**Pacific Gas and
Electric Company**

PG&E Letter DCL-01-115

Docket No. 50-275, OL-DPR-80
Docket No. 50-323, OL-DPR-82
Diablo Canyon Units 1 and 2
License Amendment Request 01-05

Revision to Technical Specification 1.1, "Definitions, Dose Equivalent I-131," and
Revised Steam Generator Tube Rupture and Main Steam Line Break Analyses

Figure 15.4.3-5 Ruptured Loop Hot and Cold Leg RCS Temperature

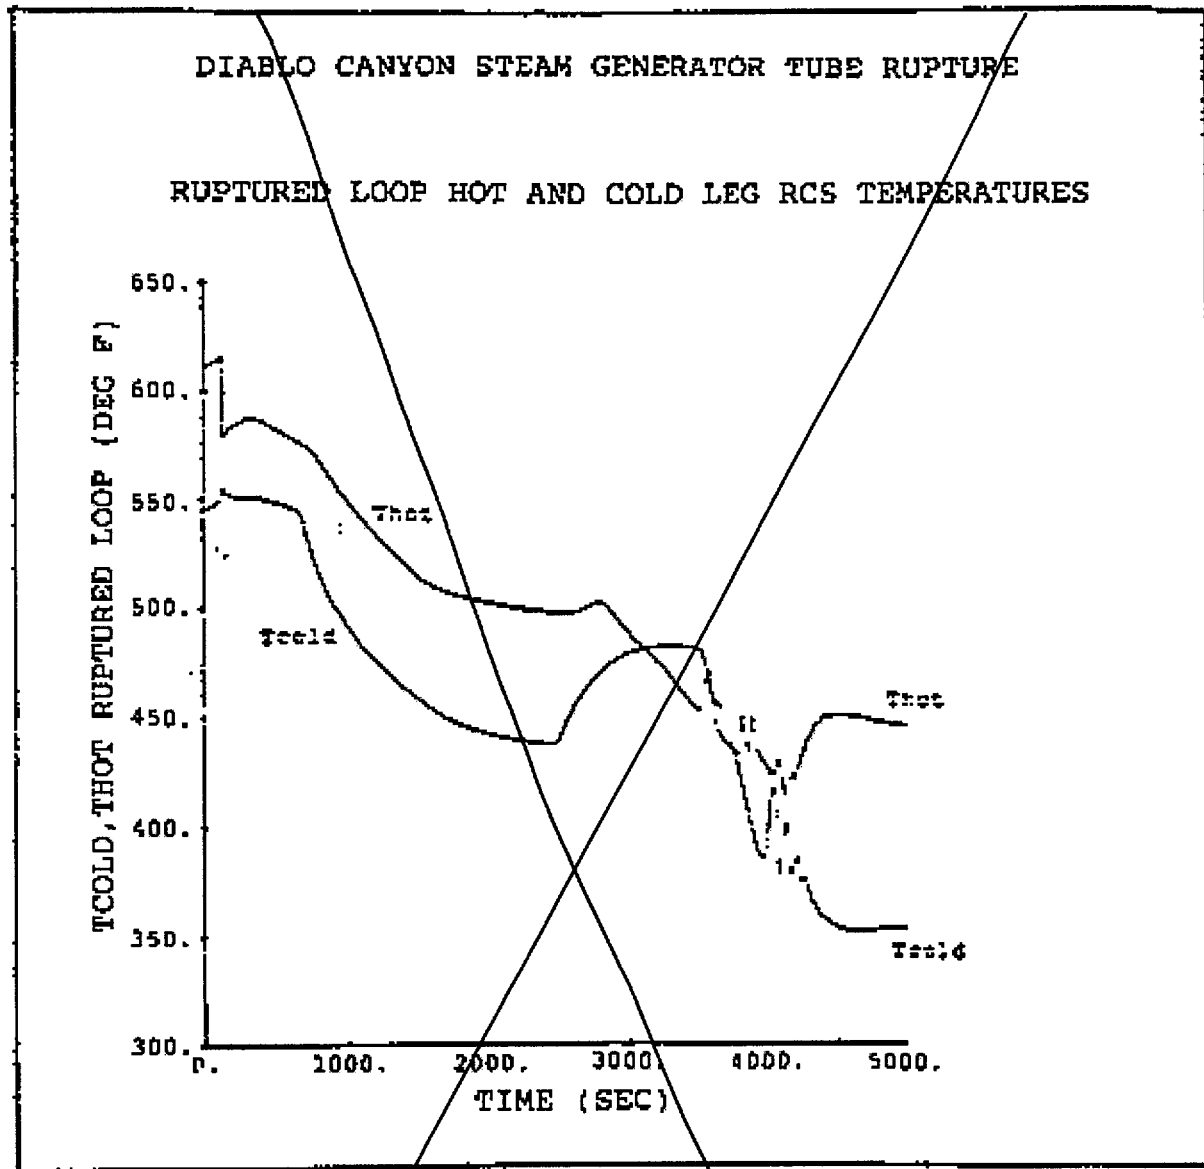
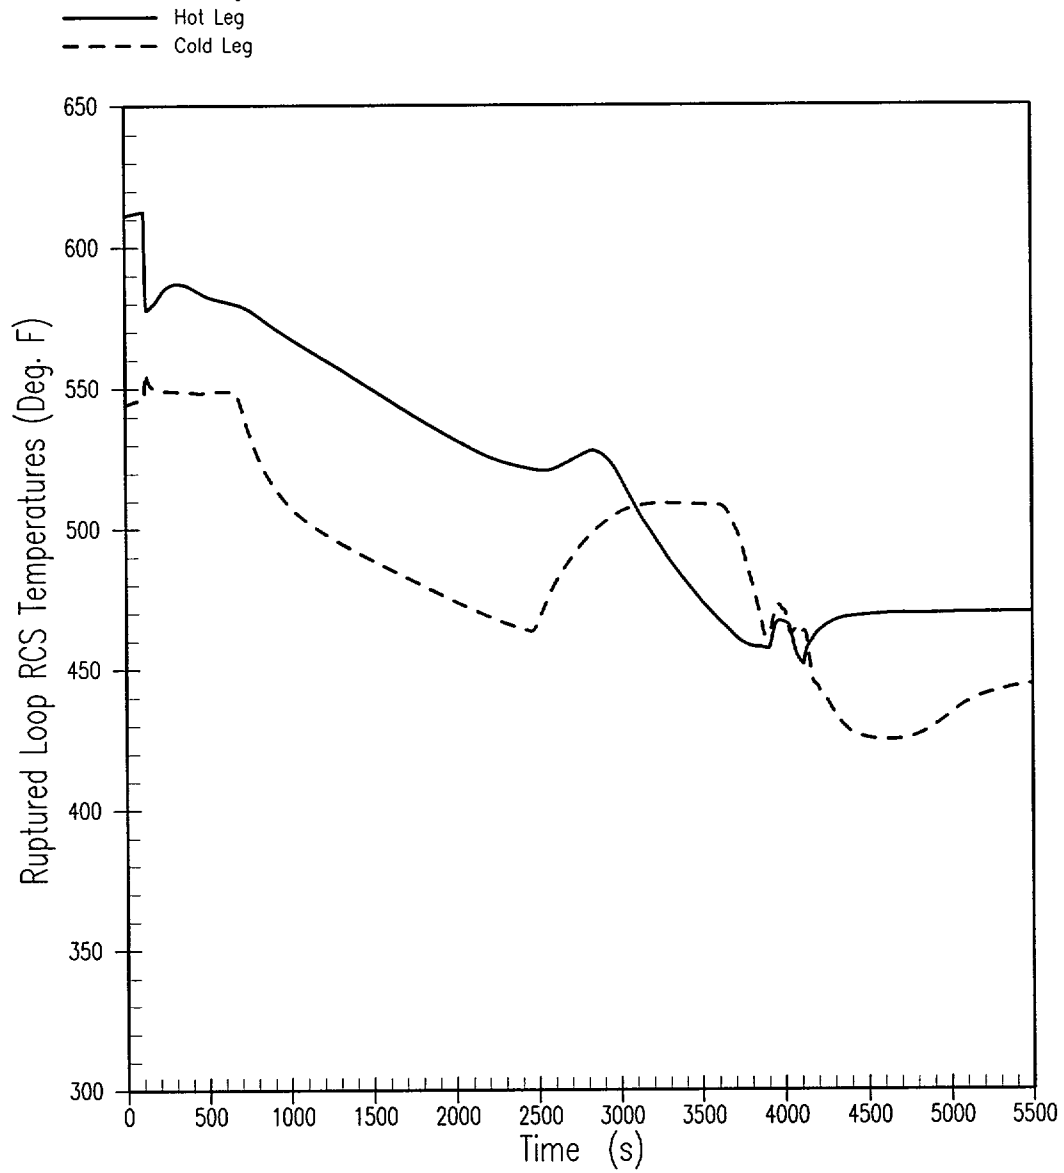
Replace with Figure 15.4.3-5

Figure 15.4.3-6 Primary to Secondary Break Flow Rate

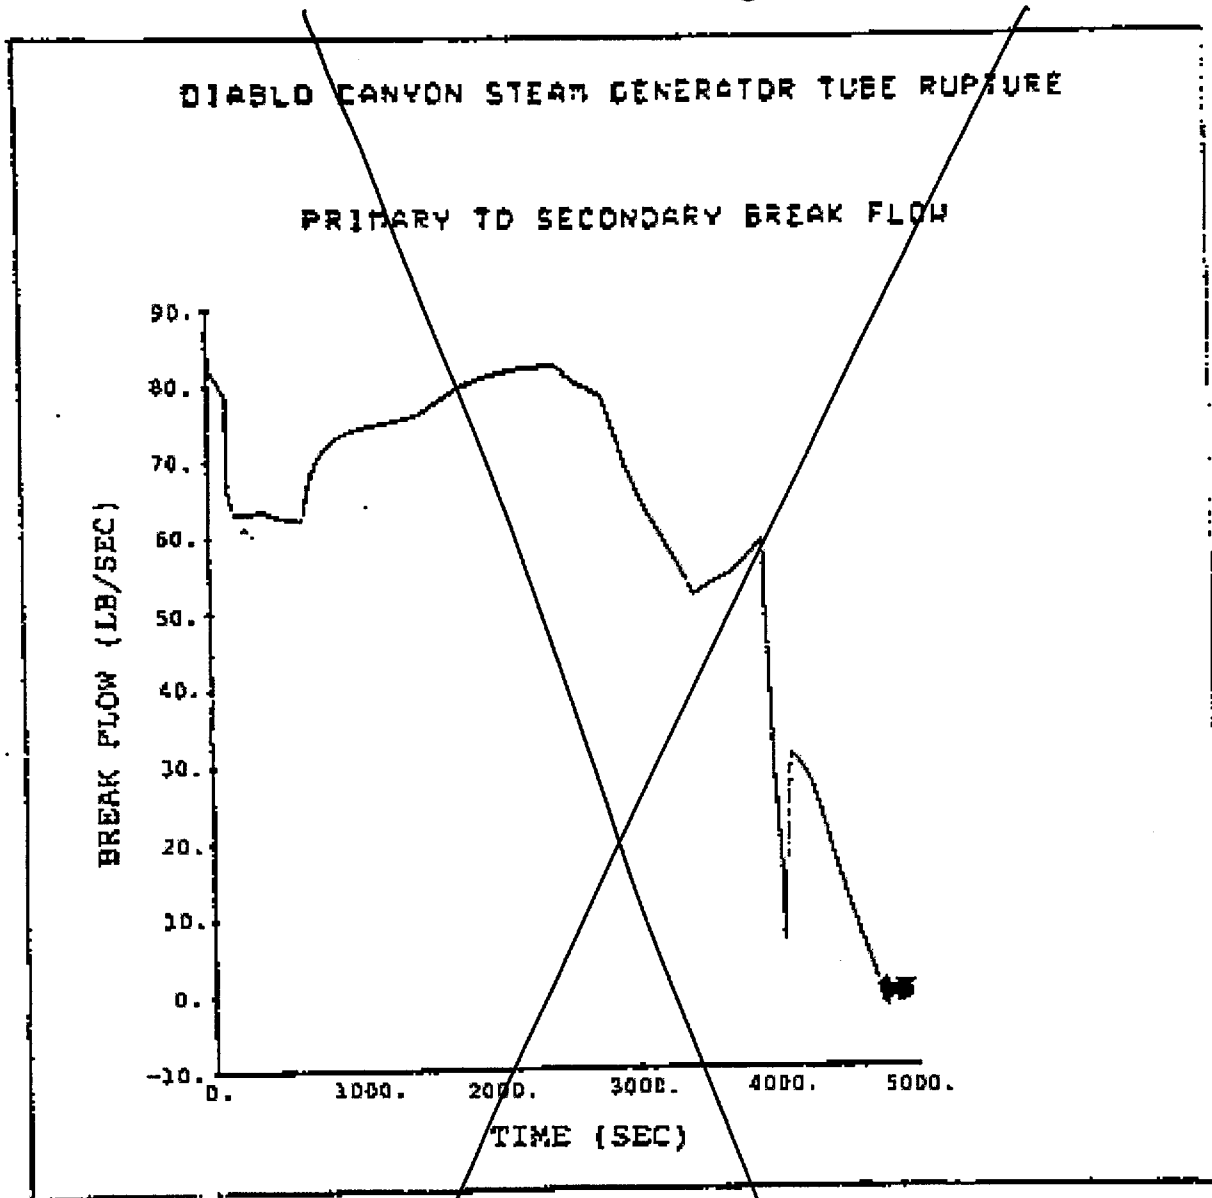
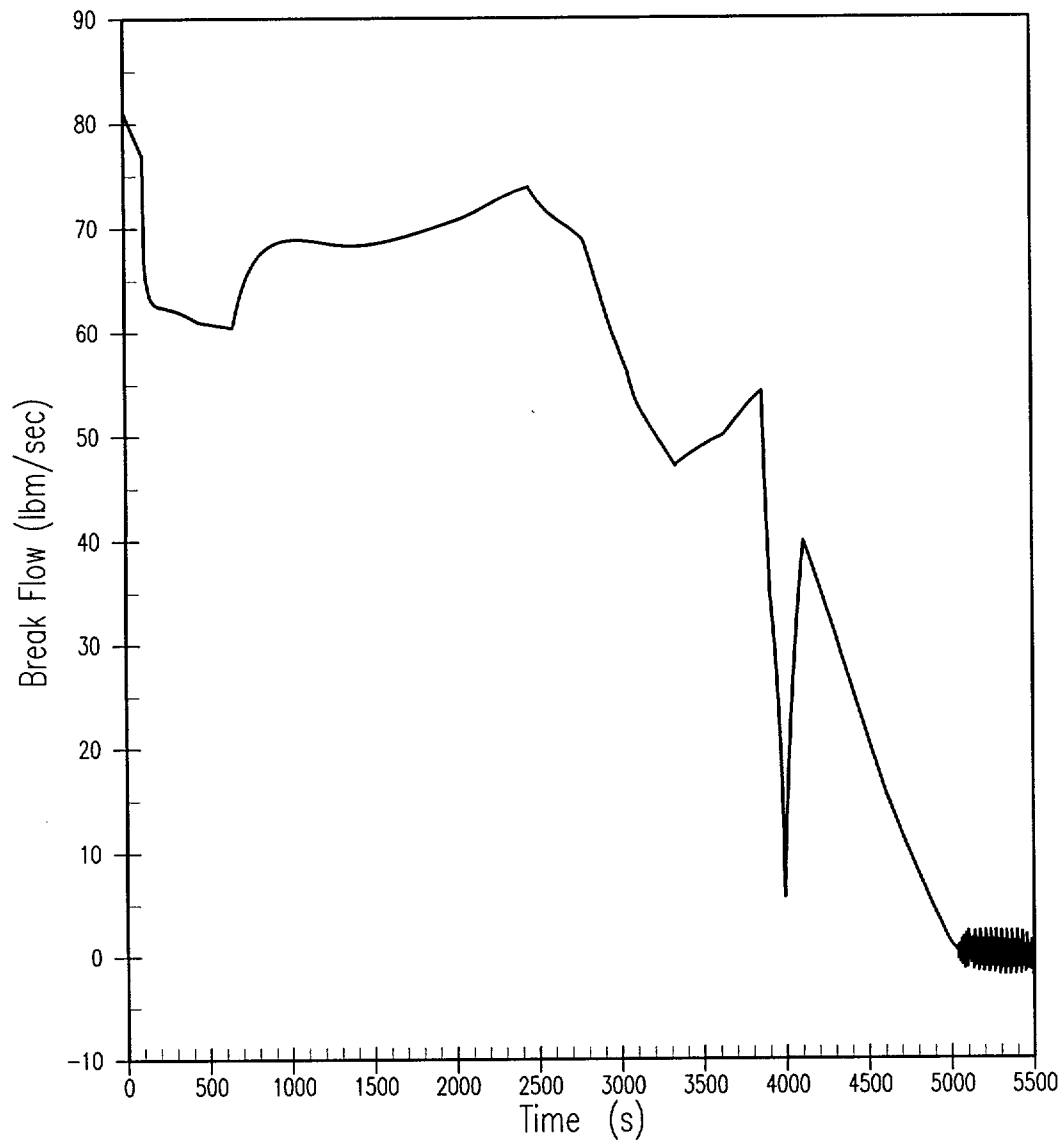
Replace with Figure 15.4.3-6

Figure 15.4.3-7 Ruptured SG Water Volume

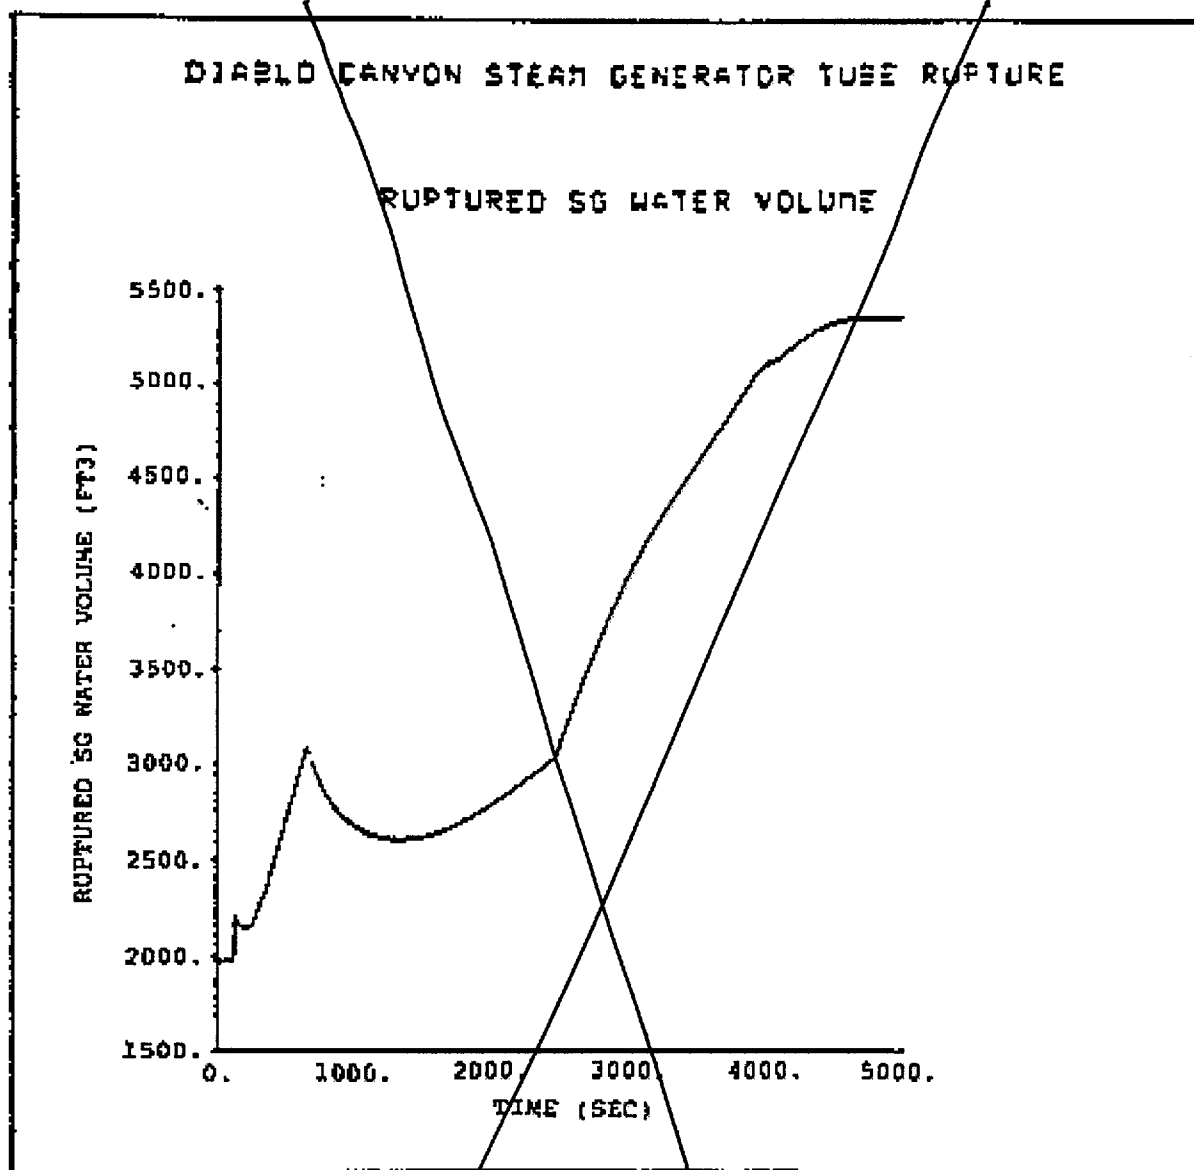
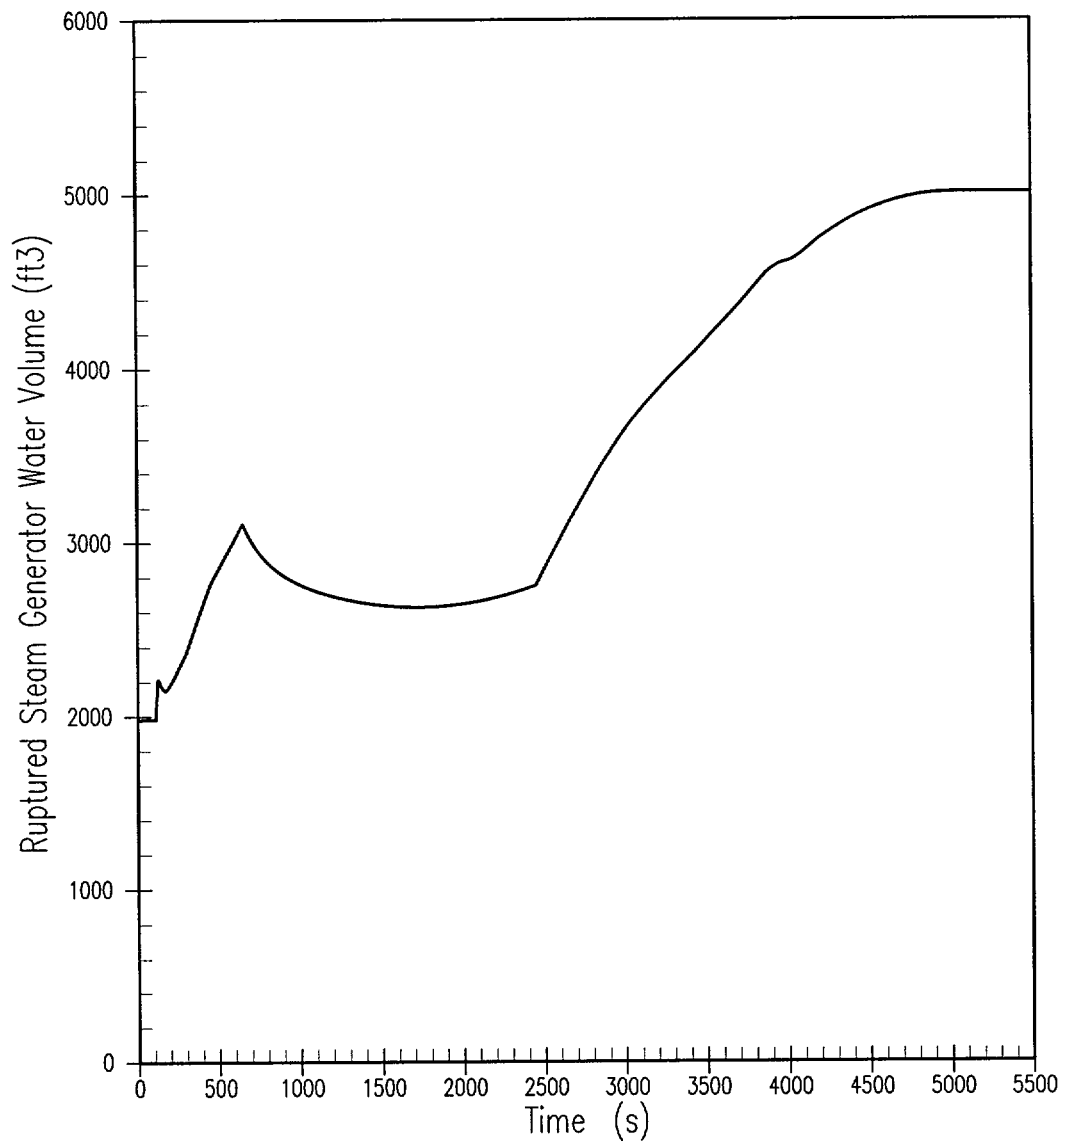
Replace with Figure 15.4.3-7

Figure 15.4.3-8 Ruptured SG Water Mass

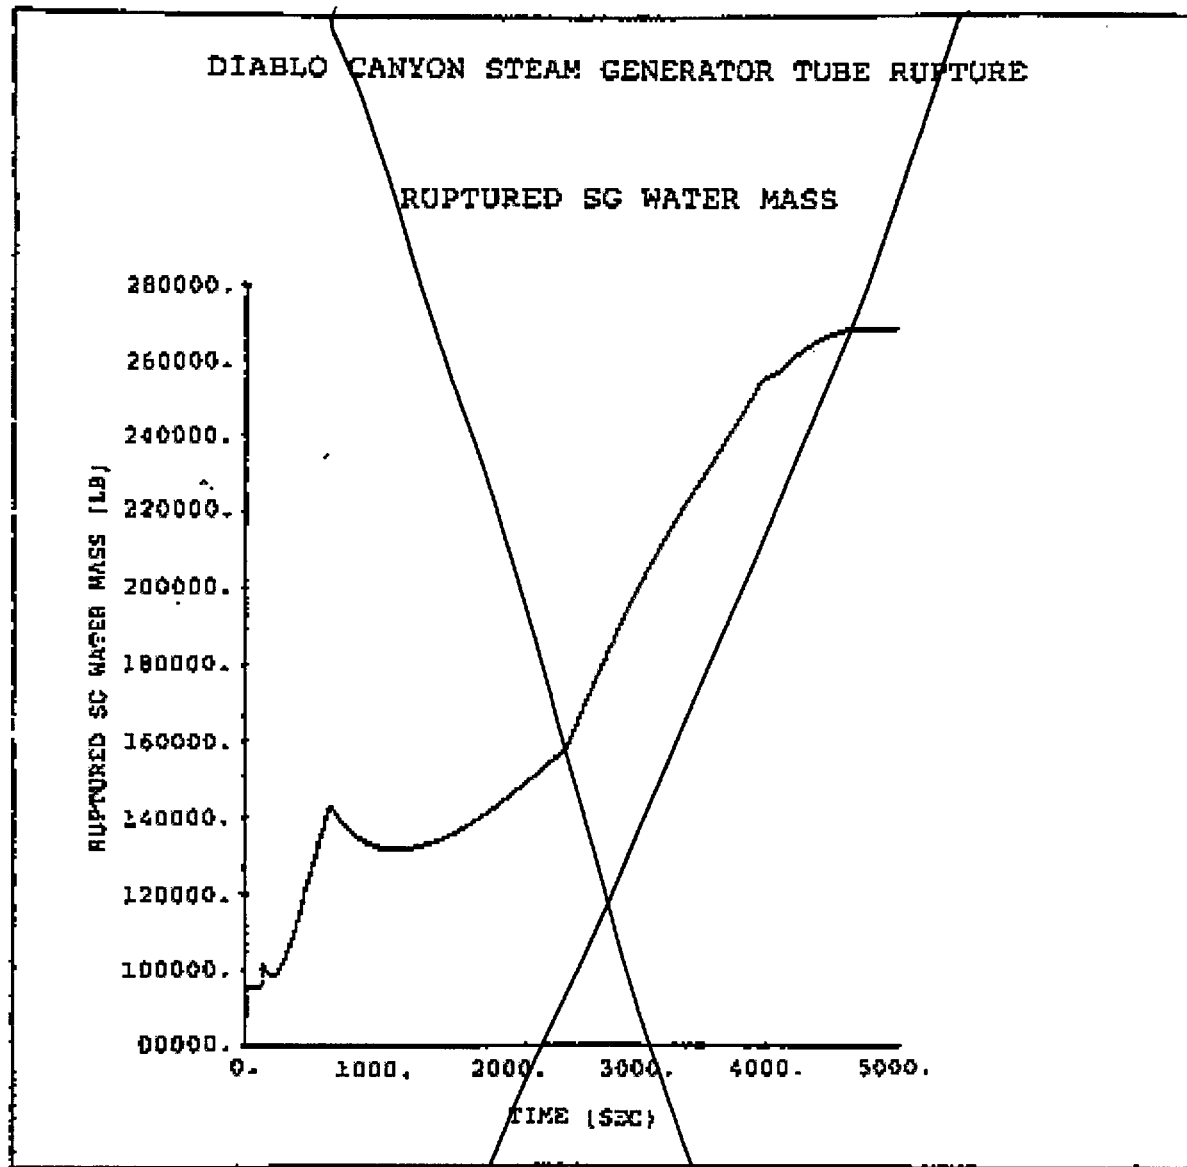
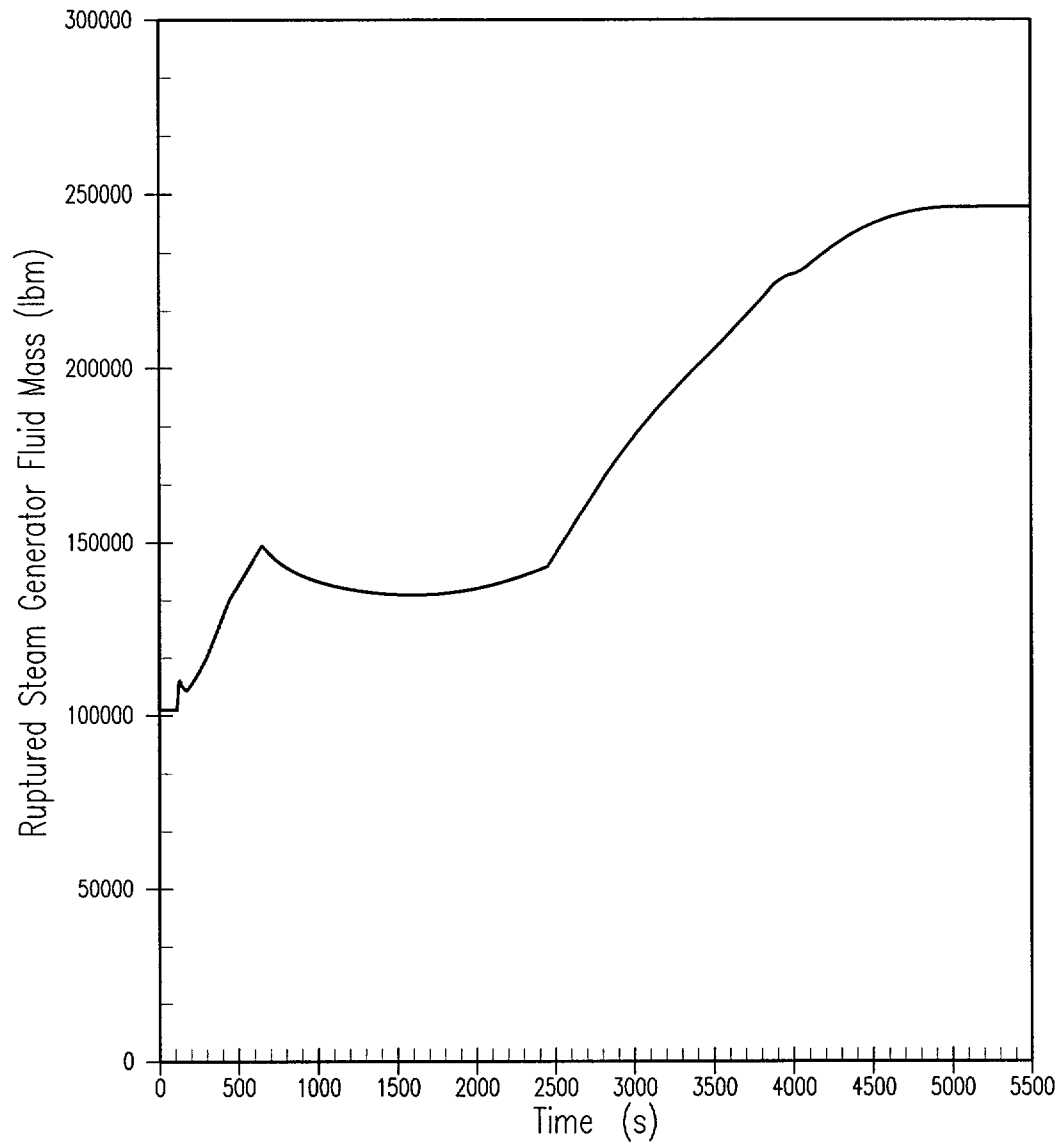
Replace with Figure 15.4.3-8
